SRRR Bracket Assembly Replacement

PB-31-032-FTL

►eCascadia

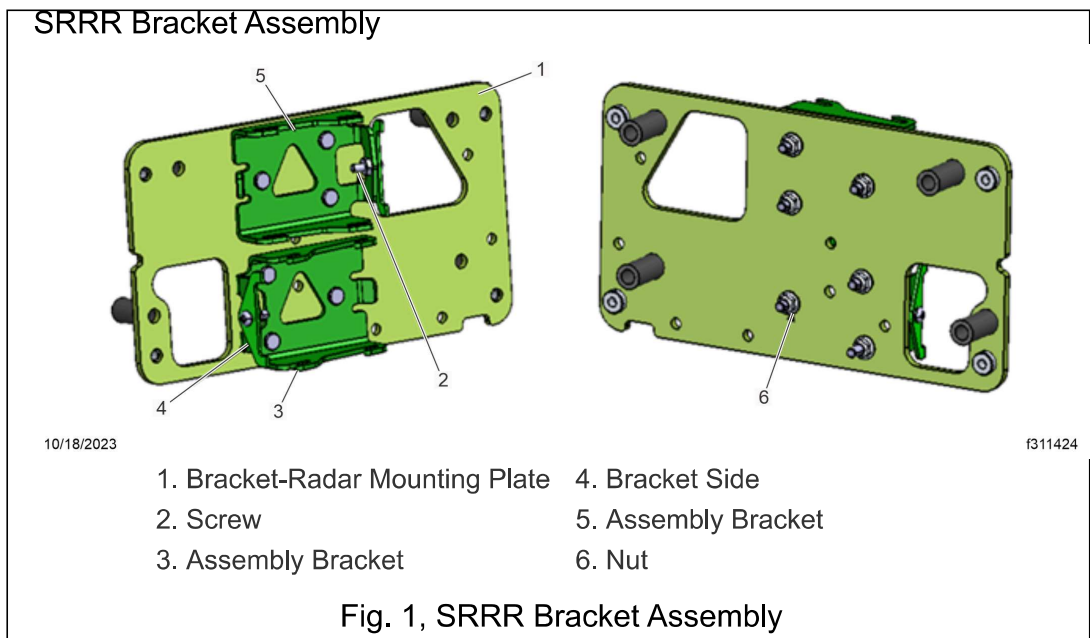
Short range radar right (SRRR) bracket assembly (A66-28620-000) is no longer available and has been replaced by a new design that may require replacement with a collection of parts found in BOM 73S-C00102. See figure [1](#).
